**ADDENDUM # 4**

**RFB #: RFB-RC-SWR-2023-06**  
**Screening Improvements Project**

**ADDENDUM 04**

Screening Improvements Project  
Contract No. RFB-RC-SWR-2023-06  
SRF Project No. C3-5368-35-00  
Rockland County Sewer District No. 1

TITLE: Remote Terminal Unit Panel (RTU-1) Exterior Cabinet Layout			
PROJECT: Rockland County Sewer District #1			
SCALE:	DRAWN BY: RCL	CHECKED BY: SRM	APP'D BY: SRM
DATE: 08/11/21	SHEET 1	OF SHEETS 2	DRAWING NO. 2105007-A1

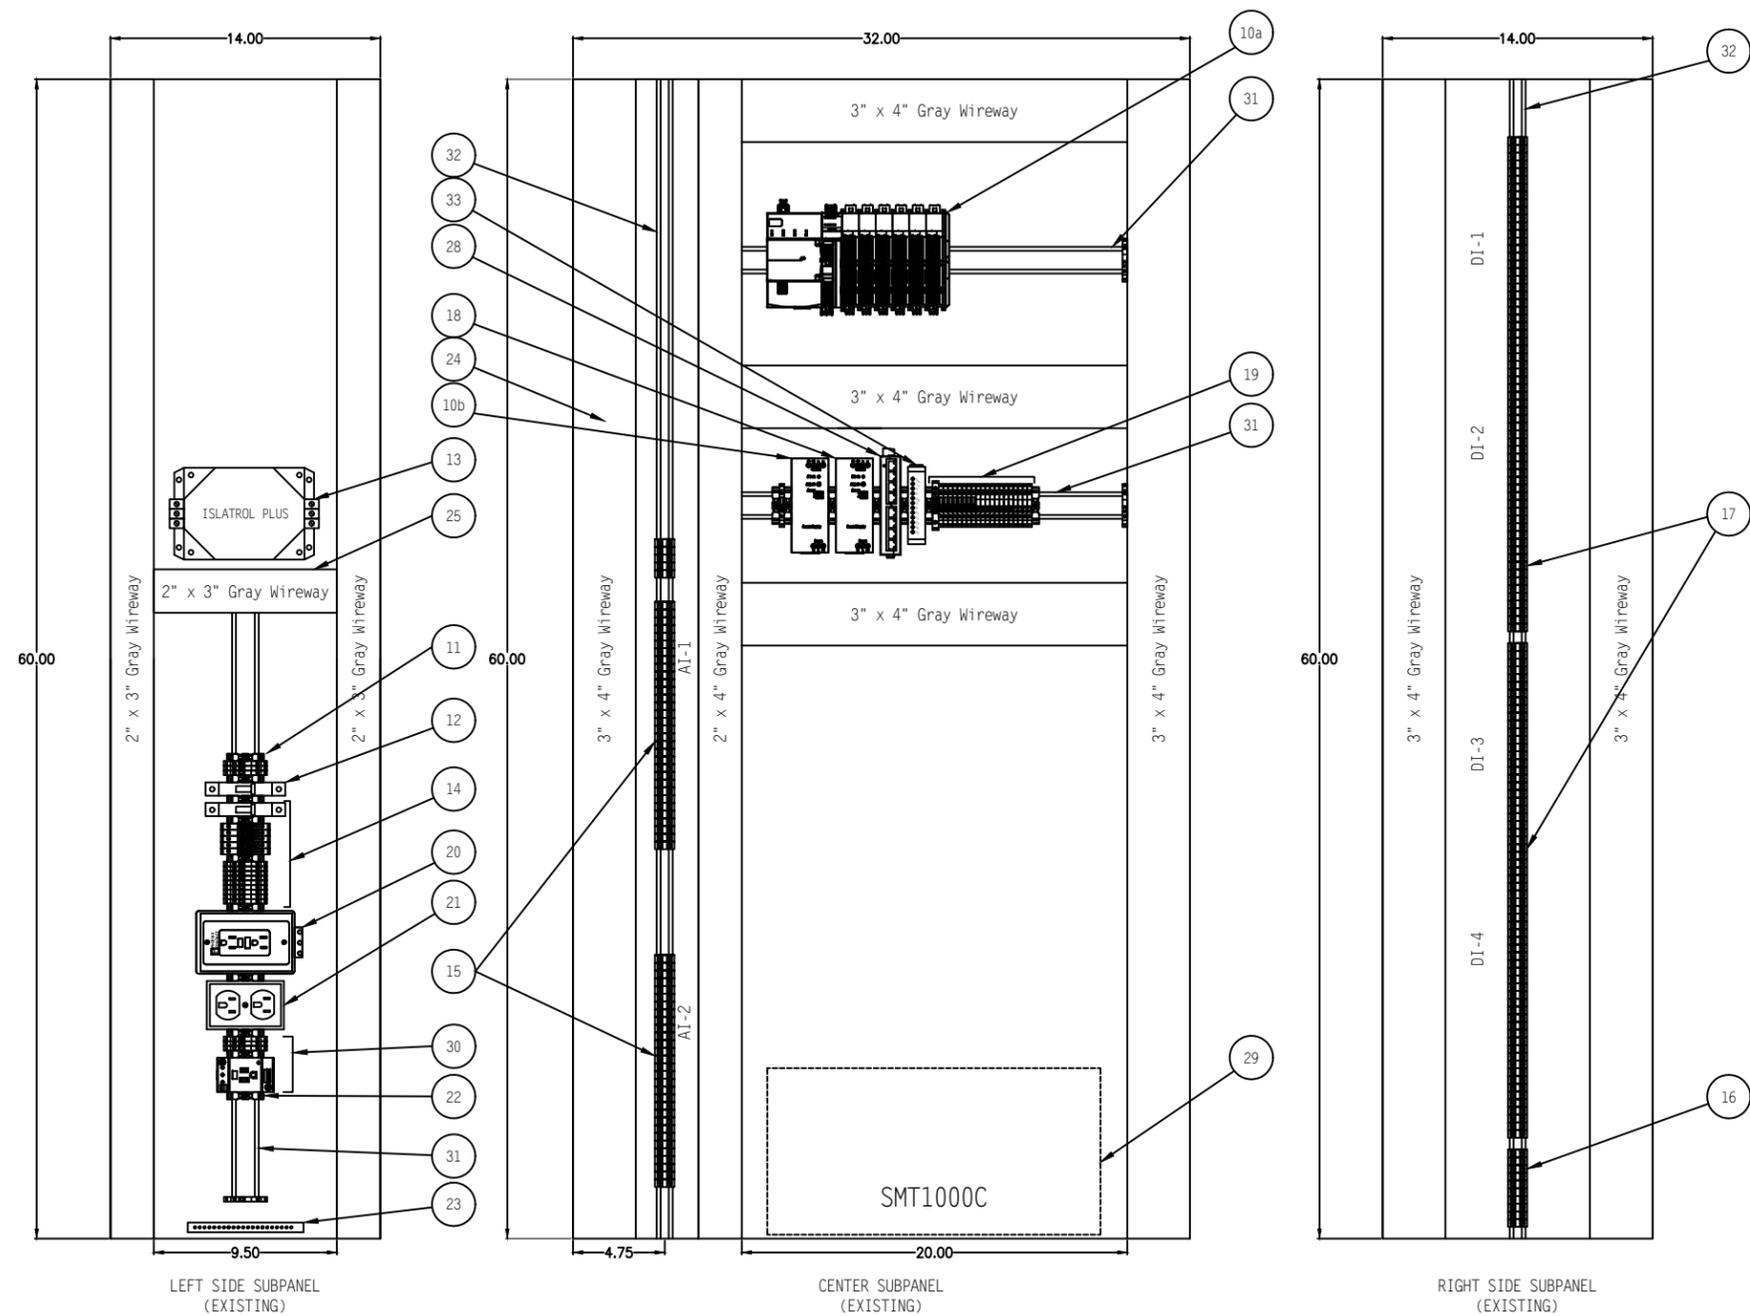
Specification section 40 63 43 part 2.01.A - last sentence states "Refer to Rockland County drawing 2105007-A1 for additional details of existing RTY-1PLC. No Substitutions will be permitted. It does not appear that the reference drawing has been provided in the issued contract documents. Please provide or clarify.

- Item 12. Specification Section 40 63 43 – Programmable Logic Controllers (PLC), paragraph 2.01.A states: "Refer to Rockland County drawing 2105007-A1 for additional details of existing RTU-1 PLC." The most current drawings for the existing RTU-1 PLC are attached as **Attachment No. 4**.

DATE:	JUNE 2024
HAZEN NO.:	90462-000
CONT NO.:	RFB-RC-SWR-2023-06
DRAWING NUMBER:	A-03

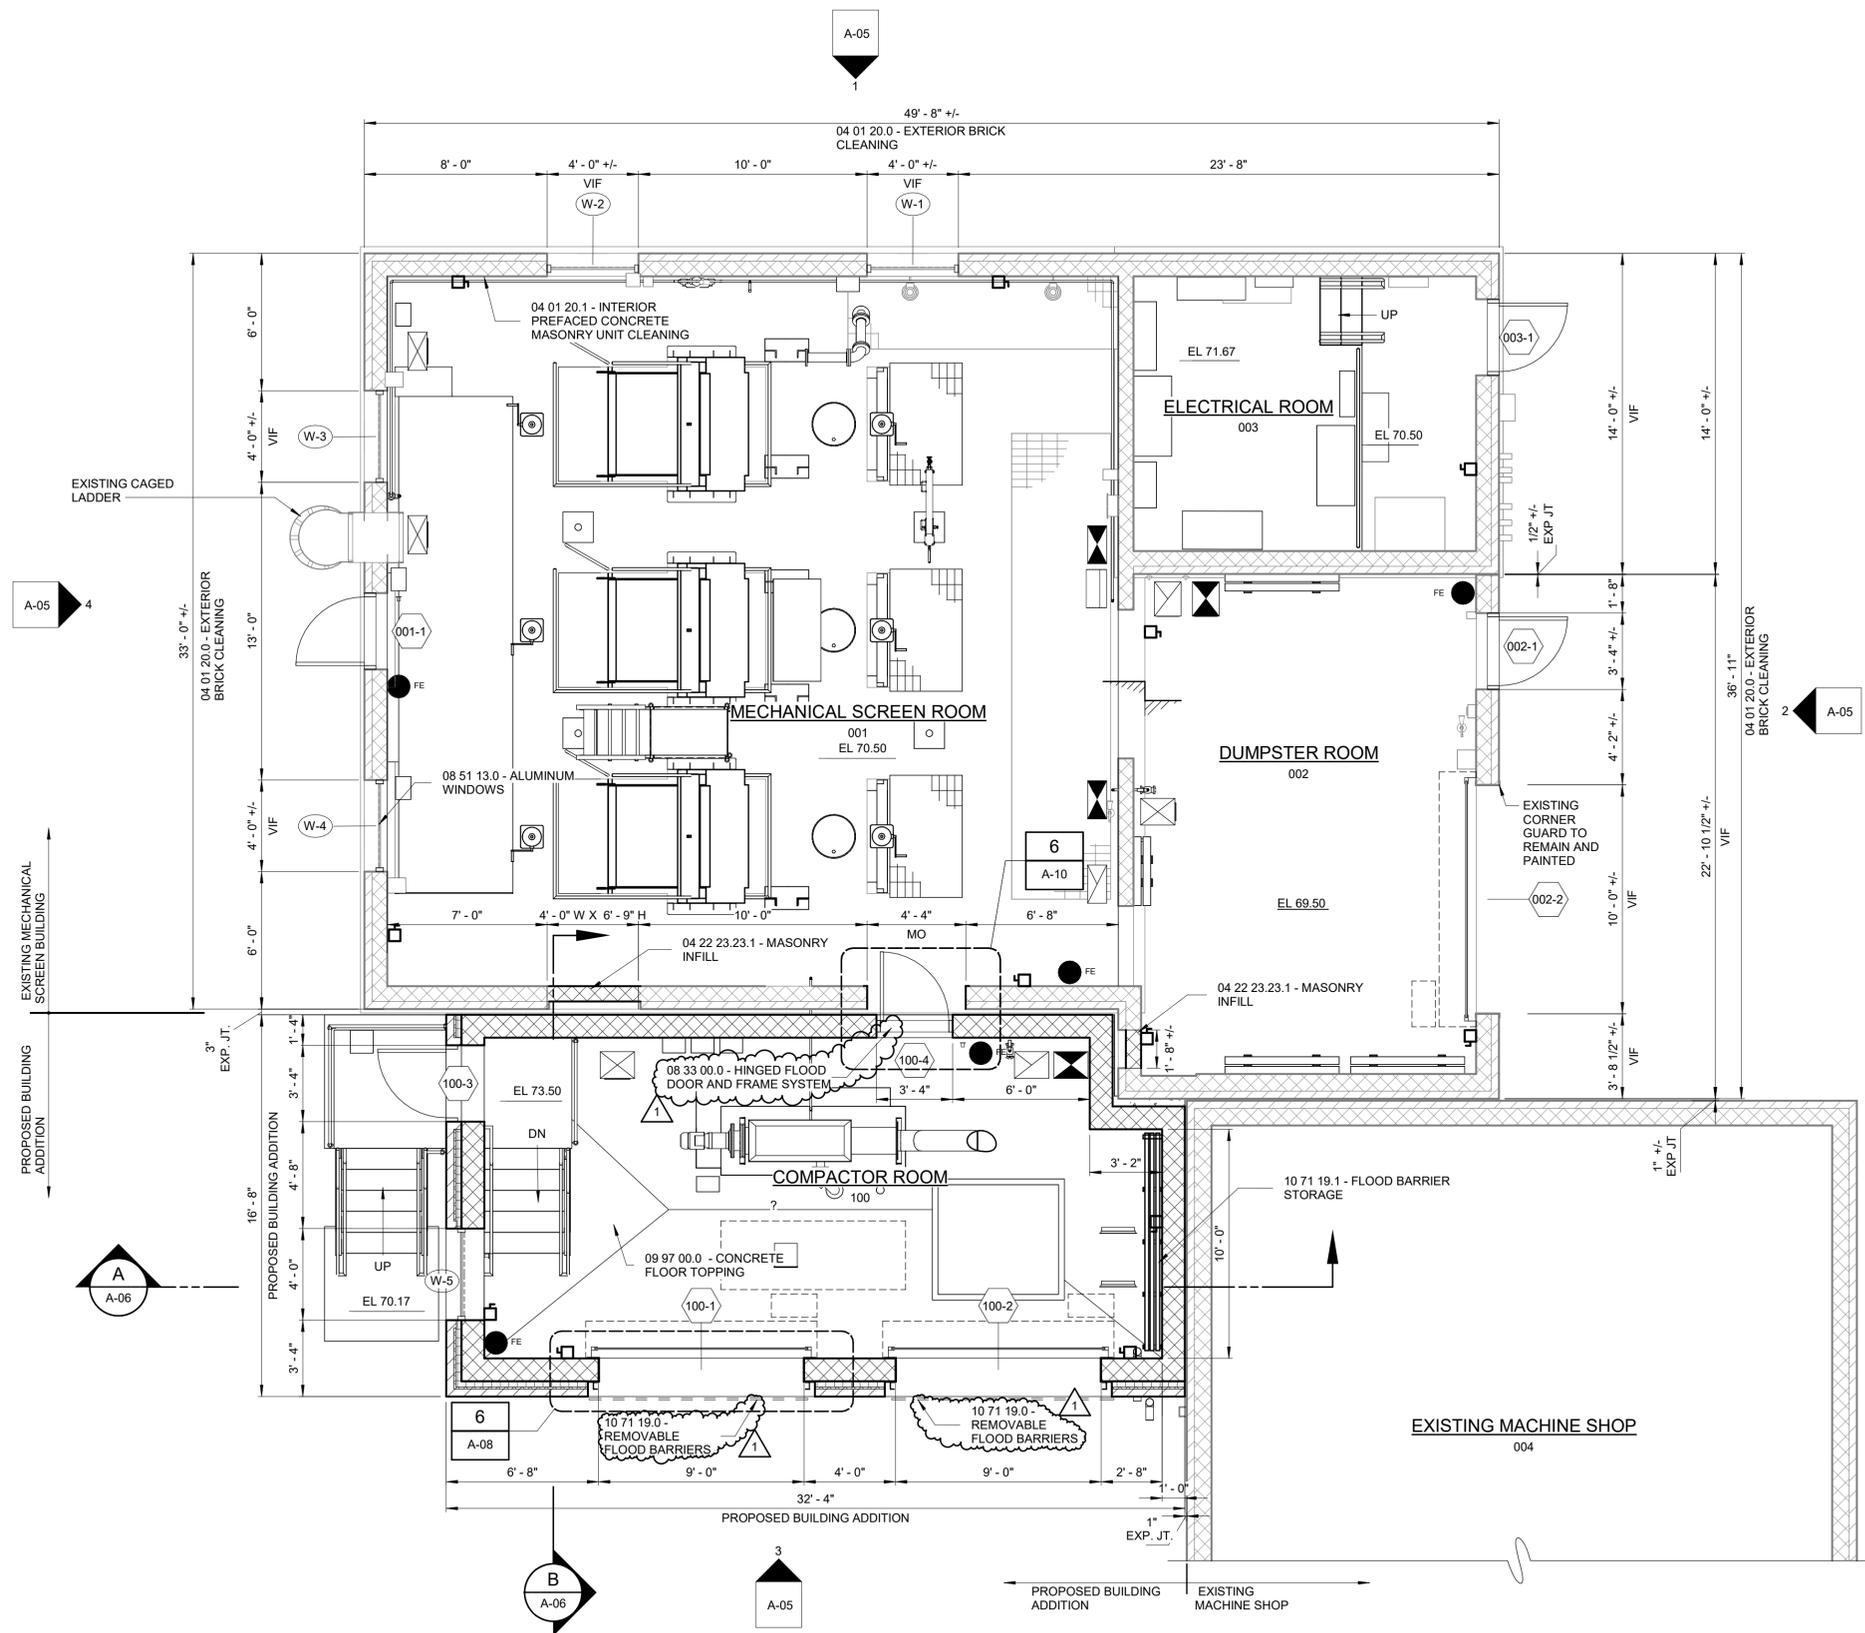
**Response:** Yes, Door No. 100-4 is the only flood door required. Drawing A-03 has been revised through this Addendum to add a callout on Door No. 100-4 for note 08 33 00.0 - HINGED FLOOD DOOR AND FRAME SYSTEM.

**Response:** Yes, flood barriers per Section 10 71 19 are required for Door No. 100-1 and Door No. 100-2. Drawing A-03 has been revised through this Addendum to add a callout on Door No. 100-1 and Door No. 100-2 for note 10 71 19.0 - REMOVABLE FLOOD BARRIERS.

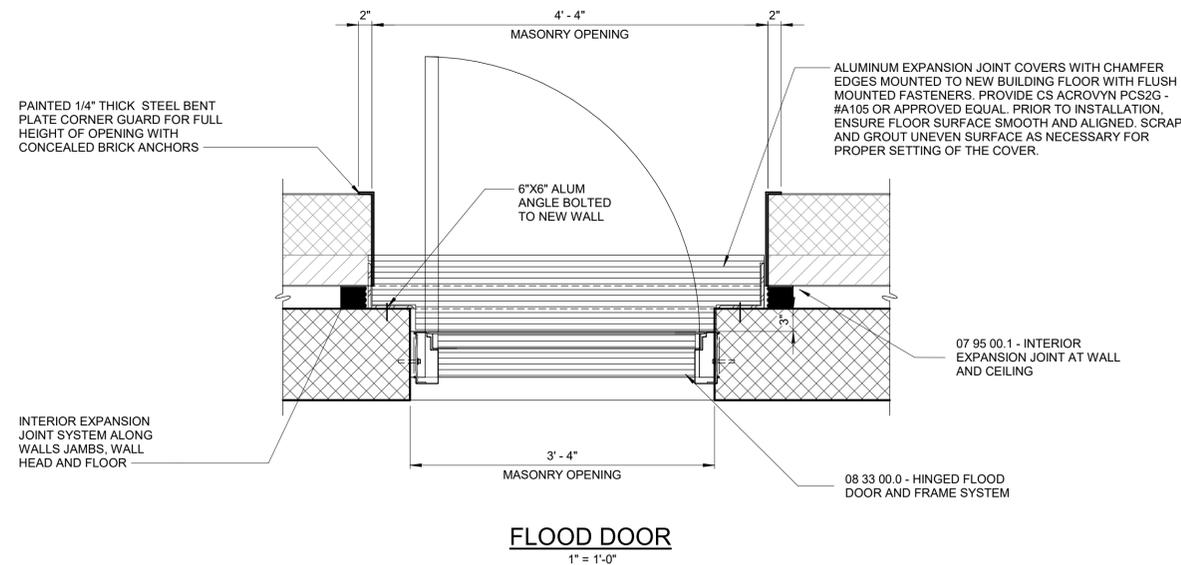
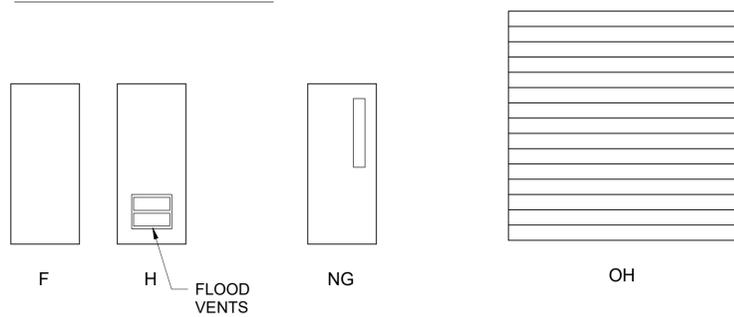
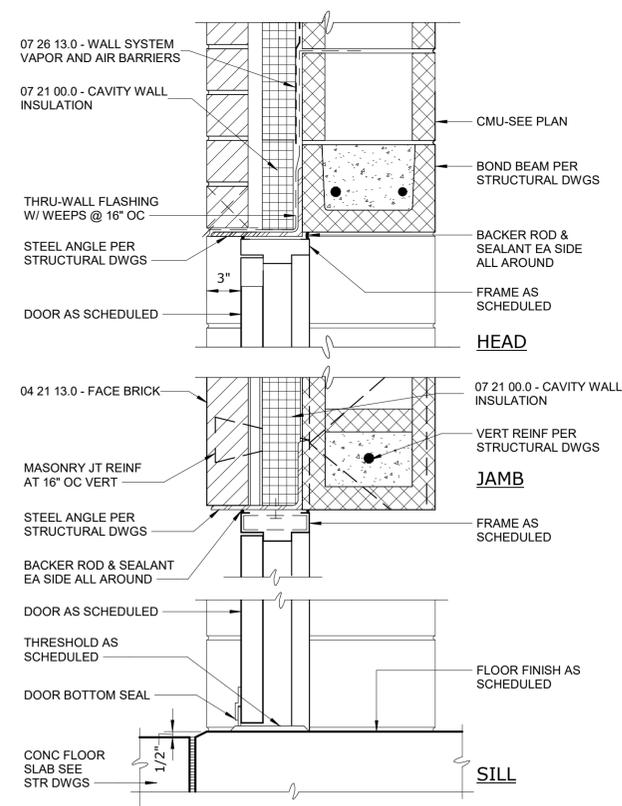
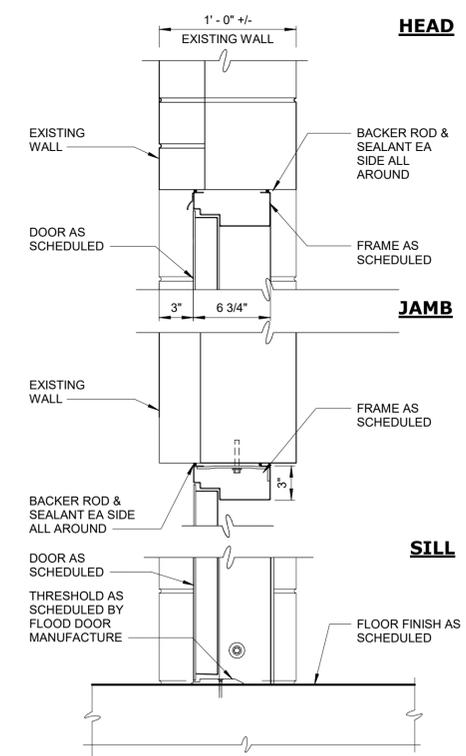
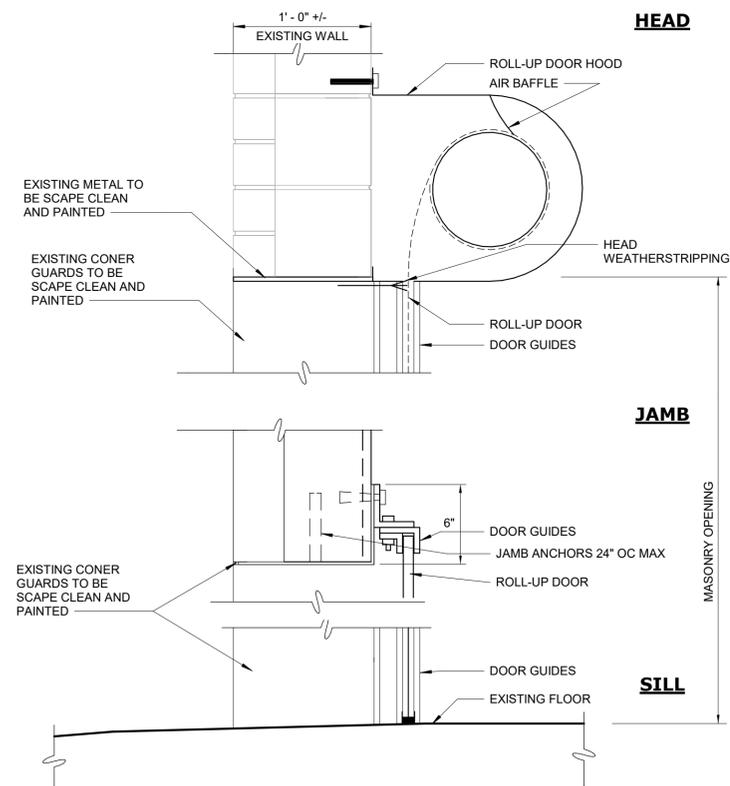
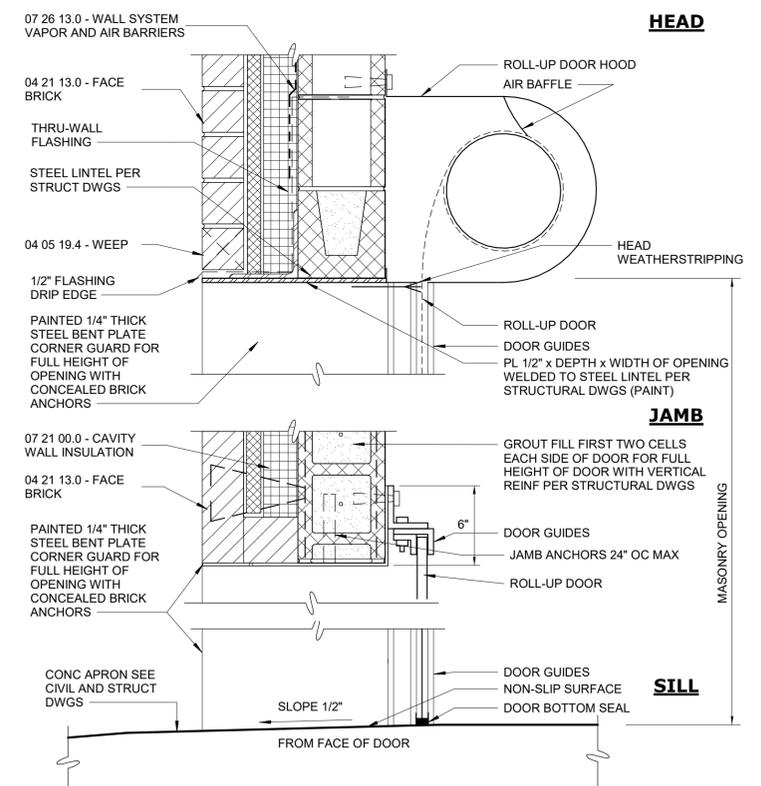
The Door Schedule on drawing A-10 indicates that new overhead doors No. 100-1 and No. 100-2 are motorized, and does not provide any operational information for overhead door No. 002-2. Contract drawing E-04 indicates that all three overhead doors are motorized. Please provide clarification on the requirements of the new overhead doors.

**Response:** Door No. 002-2 shall be insulated and motorized. Motor operation shall be in accordance with Section 08 33 23 paragraph 2.02.i. The Door Schedule on Drawing A-10 has been revised through this Addendum to clarify.
